SERVICE BULLETIN

No. 185A

SUBJECT: Wing Ribs Stations 95 and 110 Located Below the Main Wing Fuel Cell

MODELS AFFECTED: PA-23 and PA-23-160 Apache Aircraft of Foreign Registry
Serial Nos. 23-1 to 23-1883 inclusive

PA-23
RIB REPAIR
OR
▲ RIB INSTALLATION
BOTTOM WING RIBS
AT
MAIN FUEL CELL COMPARTMENT

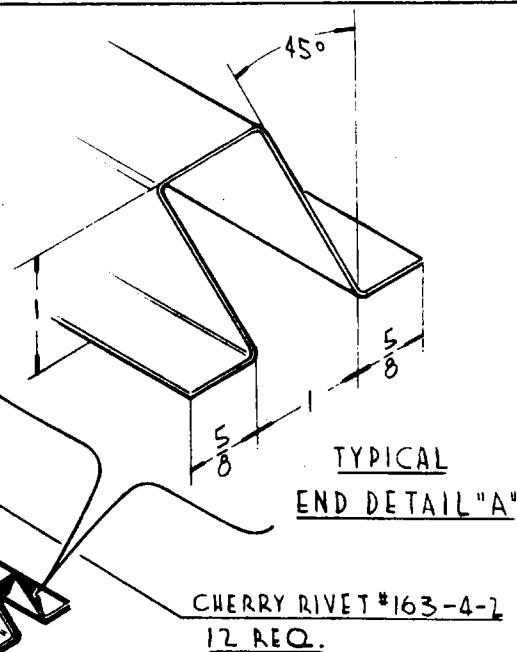
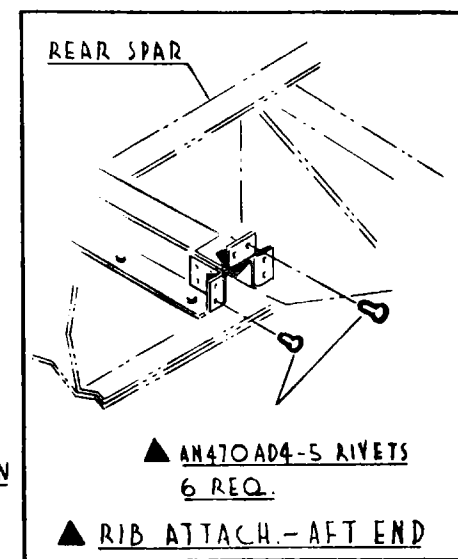
From this inspection, it is felt that the cracking of the main wing fuel cell ribs was due to landings on extreme rough terrain or from continual hard landings. Providing your airplane is operated from extreme rough terrain or unprepared runways or is subjected to continual hard landings due to student training, etc., it is recommended that the subject ribs be inspected every 500 hours and if cracked ribs are discovered they should either be replaced or repaired in accordance with the attached sketch.

DRILL .089 HOLES
6 REQ. (THRU RIB &
SPICE RIB) (STAGGER
HOLES OPP. SIDE-SEE DET. B)

REPLACE EXIST.
CLIP RIVETS WITH
AN470AD3-4 RIVETS
4 REQ. RELOCATE CLIPS
AS SHOWN (#2 LOCATION ONLY)

DRILL .098 HOLES & DIMPLE
14 REQ.
TO MATCH EXIST. RIB HOLES

REPLACE EXIST. SKIN RIVETS
WITH AN426AD4-5 RIVETS
14 REQ.

NOTE -
FORM PART OF .032
2024T3 ALUM.
FLAT PATTERN SIZE - 4 1/4 x 10 1/4
